Form 3160-5 (June 2015) UNITED STATES DEPARTMENT OF THE INTERIOR BUREAU OF LAND MANAGEMENT SUNDRY NOTICES AND REPORTS ON WELLS Do not use this form for proposals to drill or to re-enter an abandoned well. Use form 3160-3 (APD) for such proposals.			OMB	A APPROVED NO. 1004-0137

5. Lease Serial No.	Expires: January 31, 2018 5. Lease Serial No. NMNM114350 6. If Indian, Allottee or Tribe Name	
SUBMIT IN TRIPLICATE - Other instructions on page 2				 7. If Unit or CA/Agreement, Name and/or No. 8. Well Name and No. MEDWICK32 FEDERAL COM 7H 	
3a. Address 202 S. CHEYENNE AVE, SUITE 1000 TULSA, OK 74103		3b. Phone No. (include area code Ph: 918-560-7060) 10. Field and Pool (10. Field and Pool or Exploratory Area WILDCAT BONE SPRING

Cimarex Energy Co. respectfor Please see attached diagram	Illy requests approval for and procedure.	a multibowl well head.			
Also, please send updated COA for Drilling requirements for a Bone spring well.			NM OIL CONSERVATION ARTESIA DISTRICT		
,			APR	27 2017	
Accepted for record	• NMOCD - , 7	SEE ATTACHED CONDITIONS OF	FOR APPROVAL RE	CEIVED

Multibowl Wellhead Conditions of Approval

Cactus Multi-Bowl Wellhead Steps:

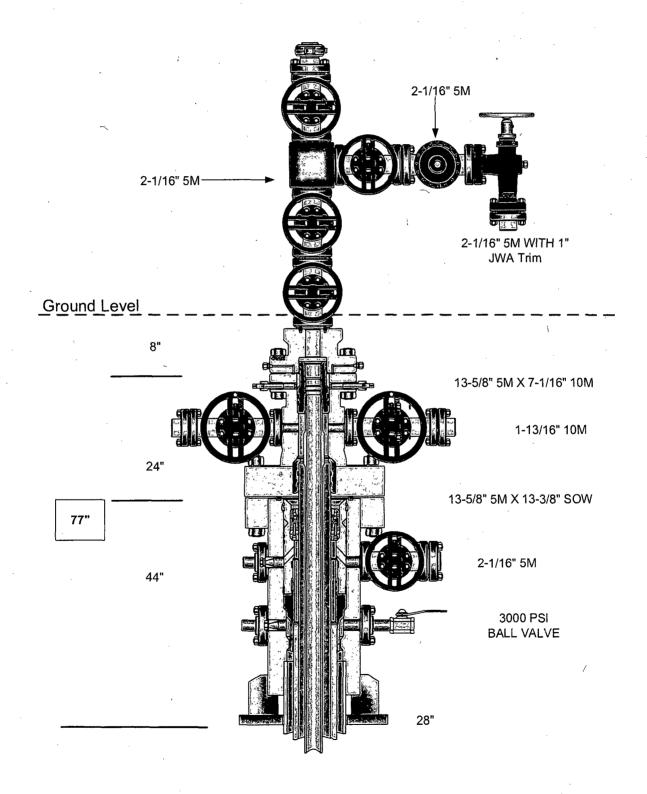
- 3. Operator has proposed a multi-bowl wellhead assembly. This assembly will only be tested when installed on the surface casing. Minimum working pressure of the blowout preventer (BOP) and related equipment (BOPE) required for drilling below the surface casing shoe shall be 3000 (3M) psi.

- a. Wellhead shall be installed by manufacturer's representatives, submit documentation with subsequent sundry.
 - b. If the welding is performed by a third party, the manufacturer's representative shall monitor the temperature to verify that it does not exceed the maximum temperature of the seal.

- c. Manufacturer representative shall install the test plug for the initial BOP test.
 - d. Operator shall perform the intermediate casing integrity test to 70% of the casing burst. This will test the multi-bowl seals.

- e. If the cement does not circulate and one inch operations would have been possible with a standard wellhead, the well head shall be cut off, cementing operations performed and another wellhead installed.
